Rezoning Application: PD 21-0220
Zoning Hearing Master Date: September 13, 2021
BOCC Land Use Meeting Date: November 9, 2021

APPLICATION NUMBER: PD 21-0220

Case Reviewer: Michelle Heinrich, AICP

2.4 Proposed Site Plan (partial provided below for size and orientation purposes. See Section 8.0 for full site plan)

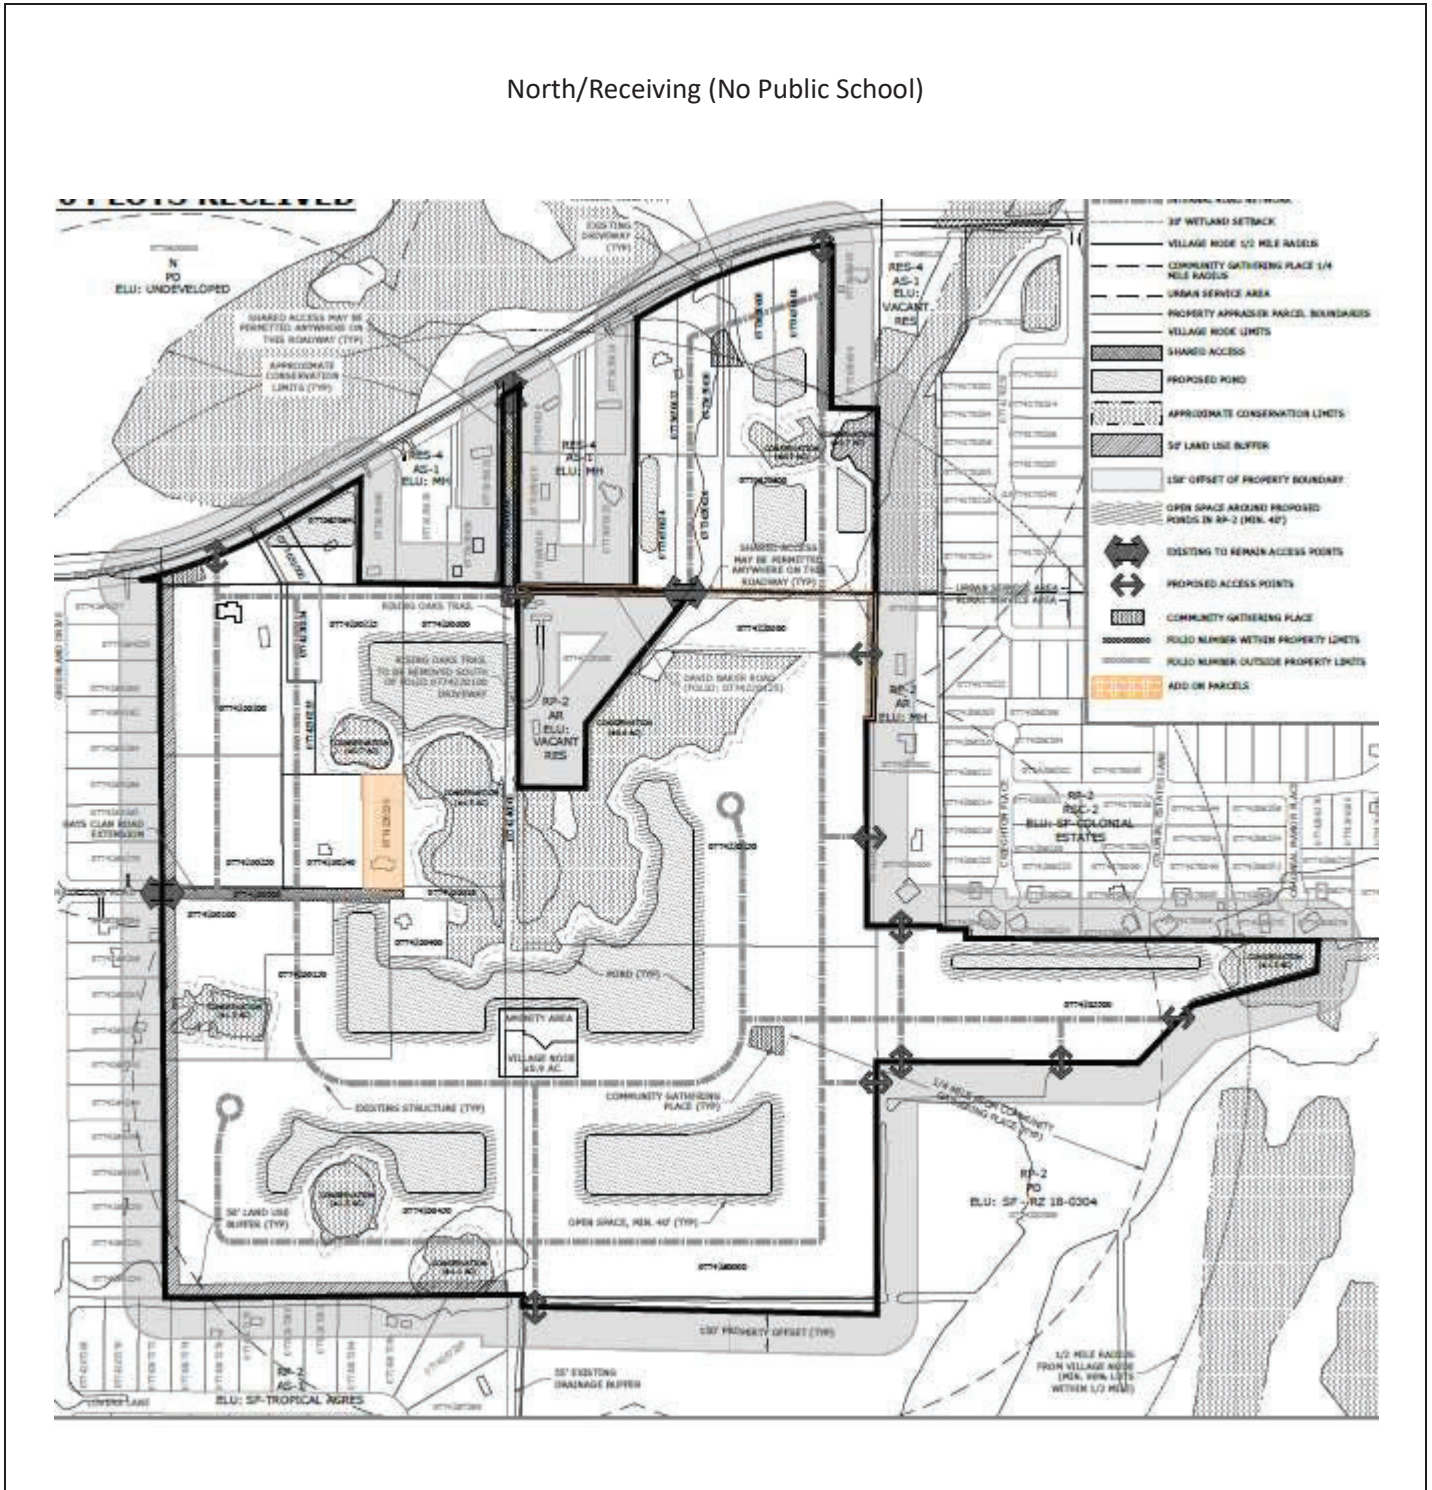
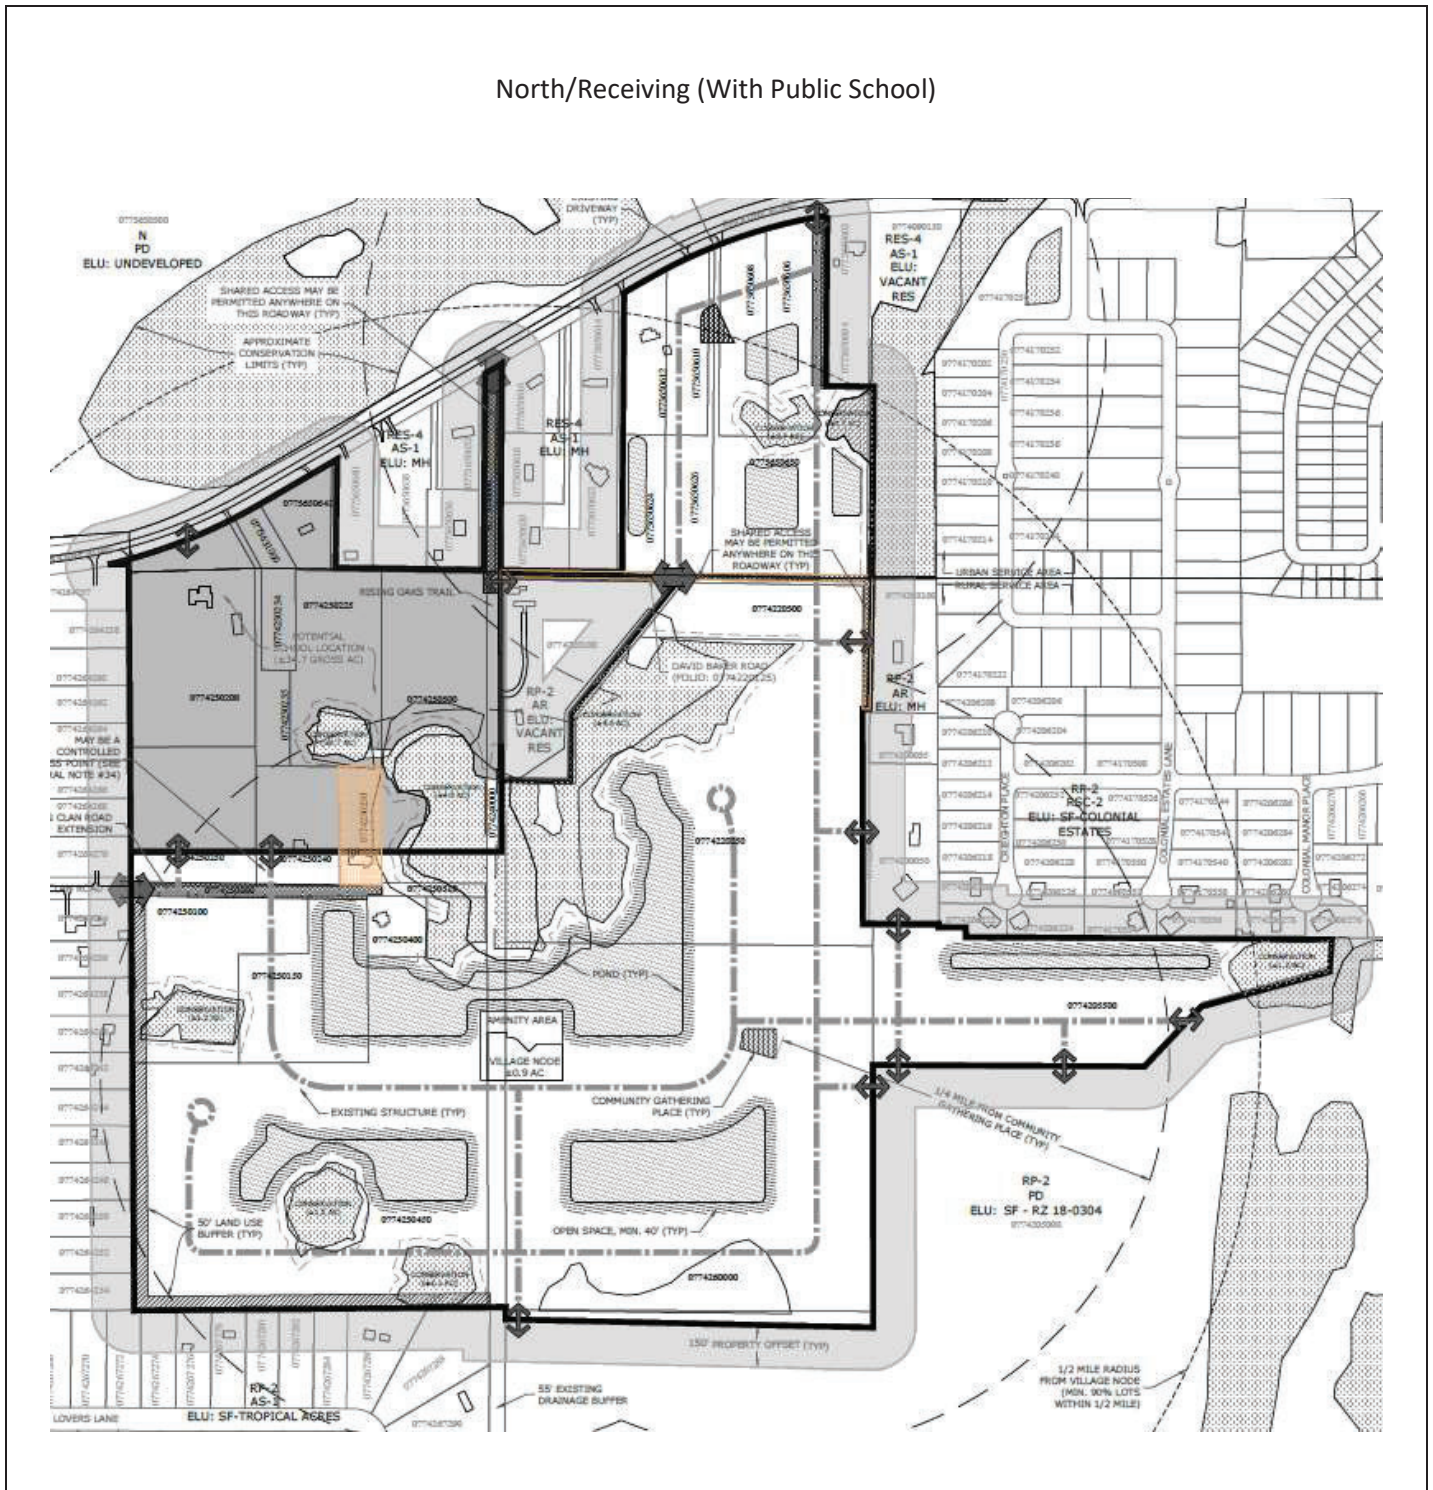
Staff has not identified any compatibility concerns with the northern project area, in both the transfer and no-transfer scenarios. The acreage addition into the northern area, an existing planned village, will result in three additional lots. These are internal to the site and will follow previously approved development standards. The transfer of 25 lots from the southern (donating) area will be located within the RP-2 area, which are again internal to the site with no modification to previously approved development standards. No access or development area changes are proposed that would alter previous compatibility reviews for the northern area.

A reduction in the required Planned Village buffers for the northern (receiving area) has been requested, as was requested and approved in PD 20-0969 and PD 19-0310. The project is proposed to remain at a reduction from 70% of the perimeter provided with a 250-foot wide buffer to 21% (if developed with a public school) or 29.6% (if not developed with a public school). These adjacent areas are both developed and undeveloped. Where adjacent to developed areas, support of the reduction was and is based upon the distances of adjacent homes from the PD boundaries. Adjacent properties which are currently vacant are zoned for Planned Villages with the same development form as the subject site. Therefore, staff supports the reduction to allow continuity between the similar development patterns. As previously proposed, the western and southwestern portions will be provided with a 50 foot (as opposed to a 250 foot) wide buffer. This reduction continues to be supported based upon the enhanced screening within these areas.

The required 250' perimeter buffer around at least 70% of the site has not been addressed in the applicant's proposal. As addressed previously in the Compatibility portion of this staff report, staff is unclear if the southern site meets this requirement and if waivers are needed. No requests have been filed.

South/Sending (North with No Public School)

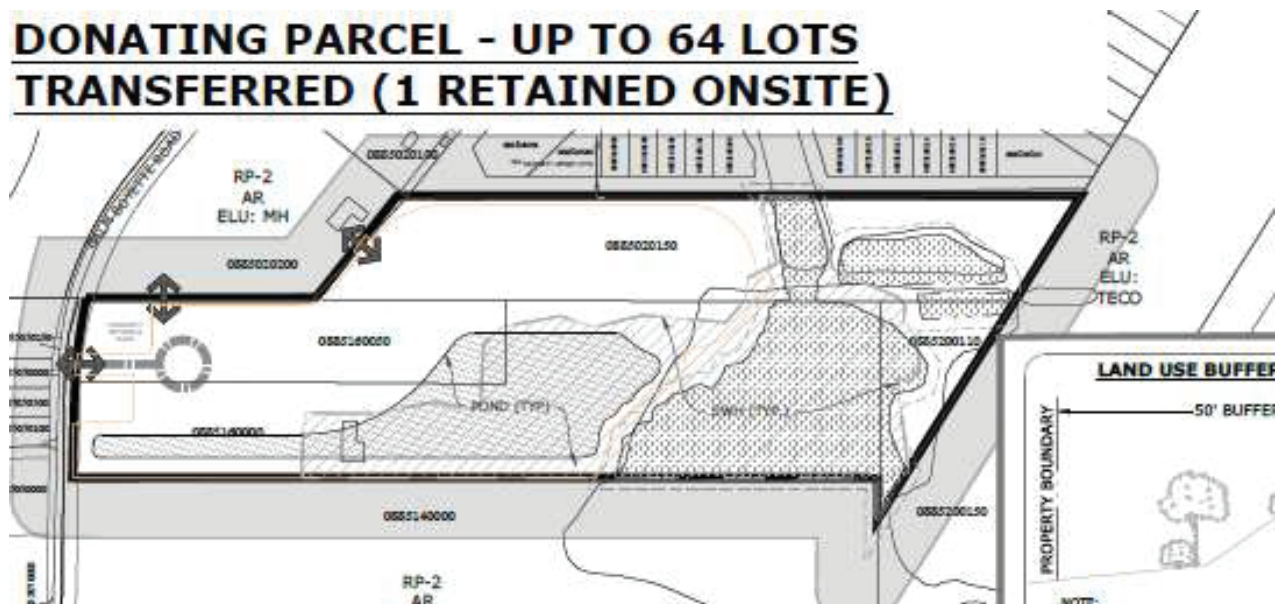
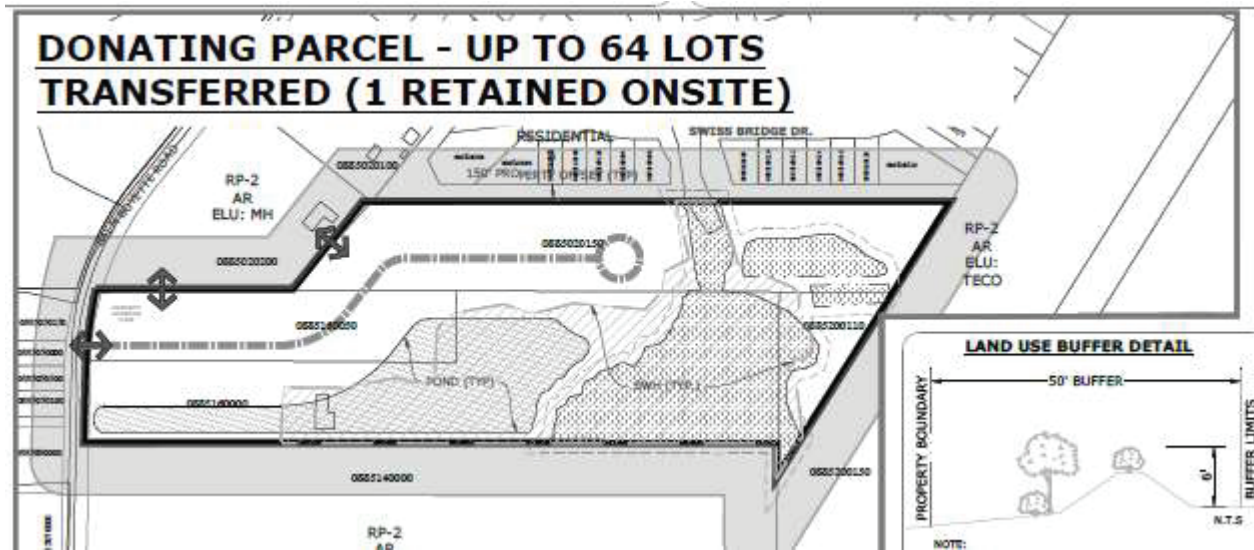
The southern PD area is depicted as two different developments per the plan sheets shown a public school present or not present in the northern PD area. Corresponding with the northern area not providing a school, the southern PD is shown to developed close to Balm Boyette Road. Corresponding with the northern area providing a school, the southern PD is shown to extend development eastward into the subject site. Under both scenarios, the property will be developed with up to one 4,000 square foot lot. Under the applicant's proposal, this would function as a Planned Village due to the proposed lot size. No required integration with the adjacent Planned Village is proposed. Compliance with the required 250 foot wide buffer around at least 70% of the site is unknown. Site Plan Sheet 3 depicts a 250' wide buffer along the eastern PD boundary, portions of the northern PD boundary and portions of the southern PD boundary. If this is not at least 70% of the entire perimeter, a waiver would be required. No waiver has been submitted. Portions of the southern and western PD boundaries show a reduced width buffer. If these are part of the 70% minimum, a waiver would be required. Therefore, staff is unable to provide a compatibility finding related to the southern PD area.

Natural Resource has filed an objection to the request. Staff does not support the development configuration for the southern PD area in both options (public school provided and not provided in the northern area). A stormwater pond is depicted within the significant wildlife habitat that requires re-location out of this area. It should be noted that Natural Resources staff advises that the 12.9 acres of SWH has not been identified as mesic or xeric. Additionally, is it unknown how much is upland SWH and how much is wetland SWH. If the habitat is xeric, a maximum of up to 50% of the upland significant wildlife habitat would need to be preserved. If the habitat is mesic, maximum of up to 25% of the upland significant wildlife habitat would need to be preserved.

Sheet 2 of 4

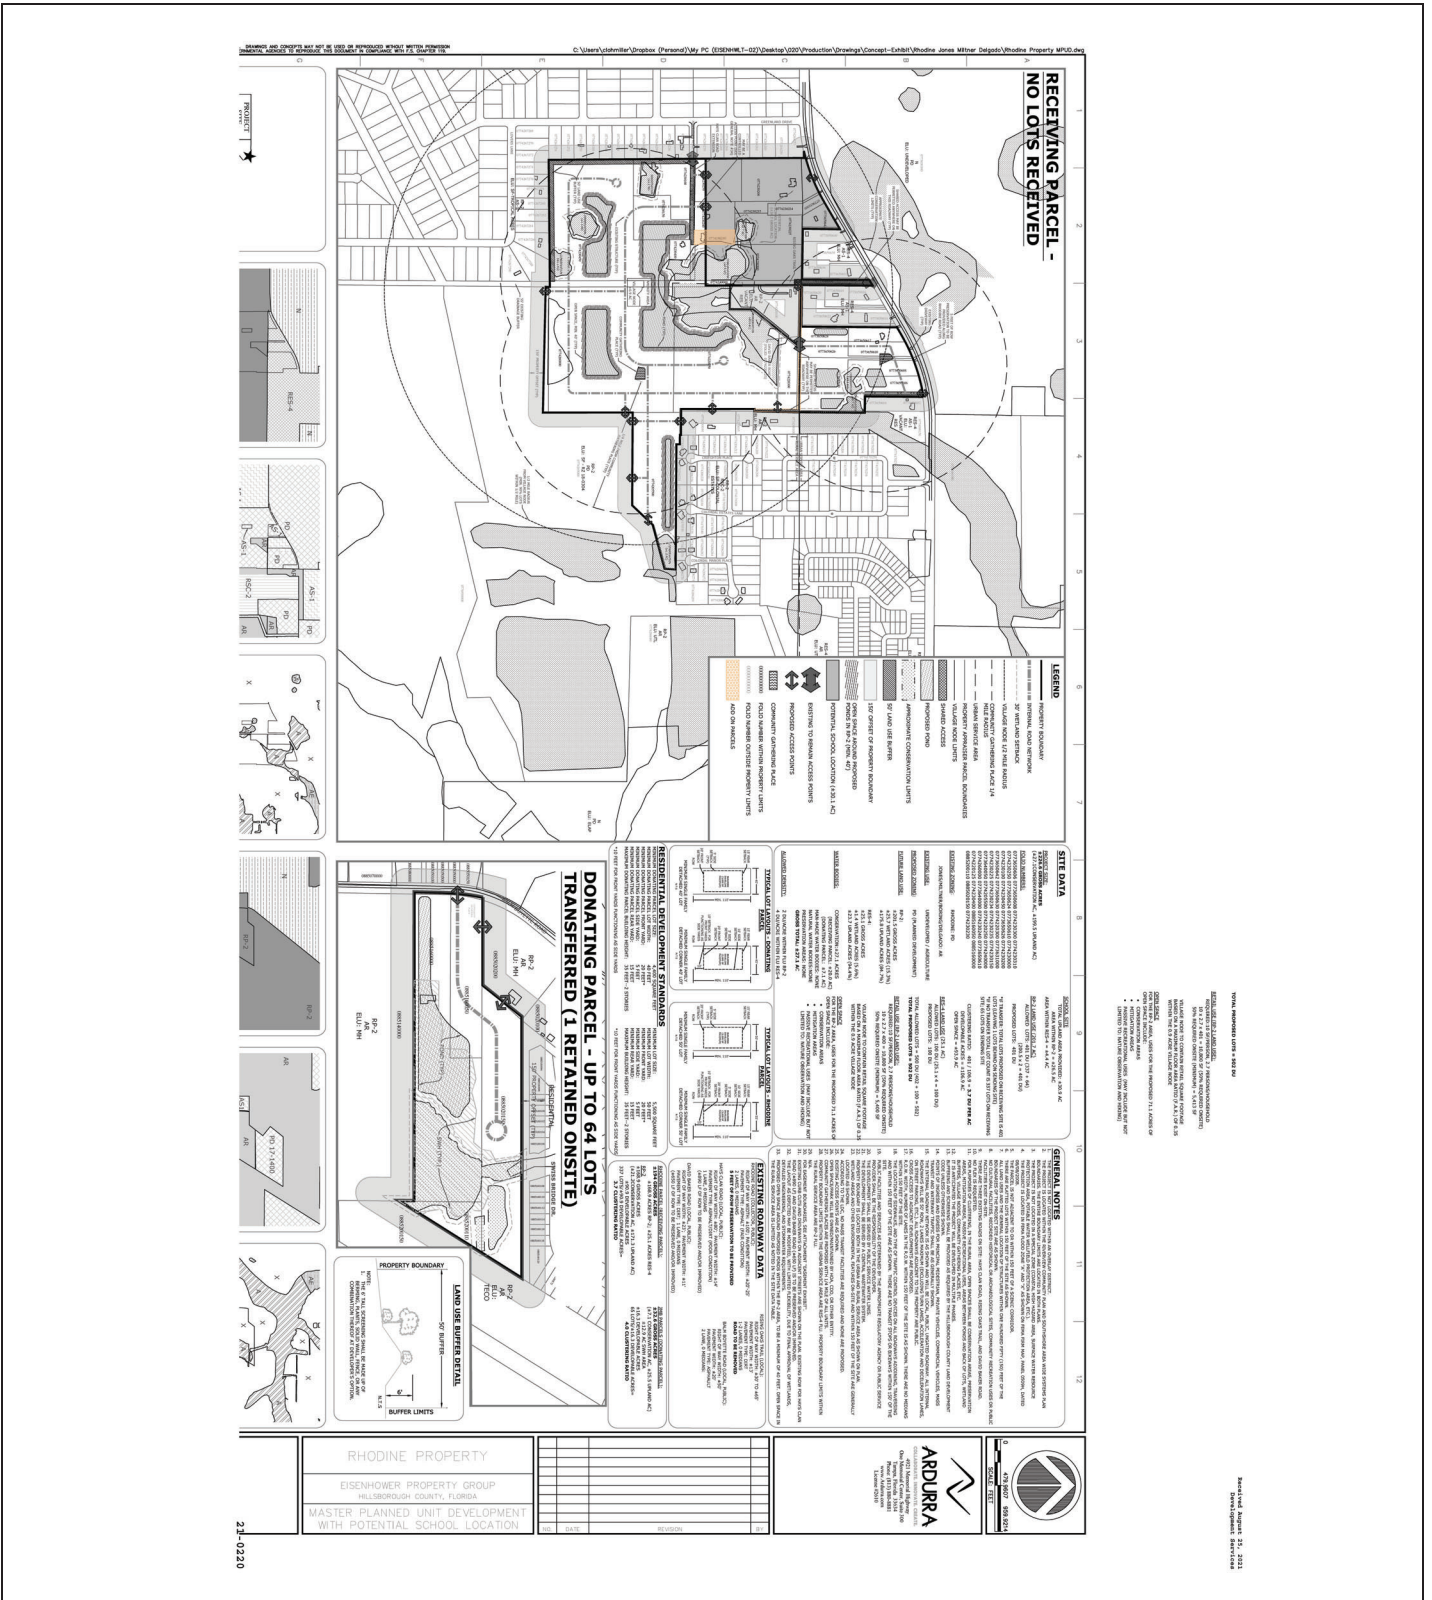
Numerous discrepancies on the site plan sheets has created uncertainty regarding the request and possible conflicts should only portions of the overall request be supported. The site plan sheets Sheet 1 is noted as "64 lots received in the northern area;" yet the southern area inset is noted as "up to 64 lots transferred with 1 unit remaining on site." It is unclear if a range of lots is proposed to be transferred. If so, the southern area inset's depicted development may not be accurate. Additionally, the site plan's developable acreage in the southern area would need adjustment as the number of units developed decreases to comply with the minimum clustering ratio of 3.5. Sheet 2 is noted as "no lots received in the northern area;" yet the southern area inset is noted as "up to 64 lots transferred with 1 unit remaining on site." This is conflict does not clearly state the request. Additionally, the site data table on both Sheets 1 and 2 note 401 units on the receiving site if a transfer occurs and 337 if the transfer doesn't occur - which is less than what is currently permitted or proposed with the additional acreage proposed to be added. It is assumed that this was intended to speak to the number of lots in the RP-2 portion of the receiving site. However, this adds to the uncertainty of the request, how to properly evaluate it, and what is in the record for community review and input.

5. The applicant's intent is unclear. There are multiple, substantial discrepancies in the description of unit calculations and allows/proposed lots as shown in the site data table (for example, one calculation shows 500 allowable lots, yet proposes 502 lots). Additionally, at the top of the sheet which contains the development option with the school site, the plan is labeled "Receiving Parcel – No Lots Received"; however, there is an inset which states "Donating Parcel – Up to 64 Lots Transferred (1 Retained Onsite)" on the same page. If the units being sent from the donating parcel aren't going to the receiving parcel, staff is unsure where they are intended to go, and the transportation analysis did not examine the additional receiving parcel.
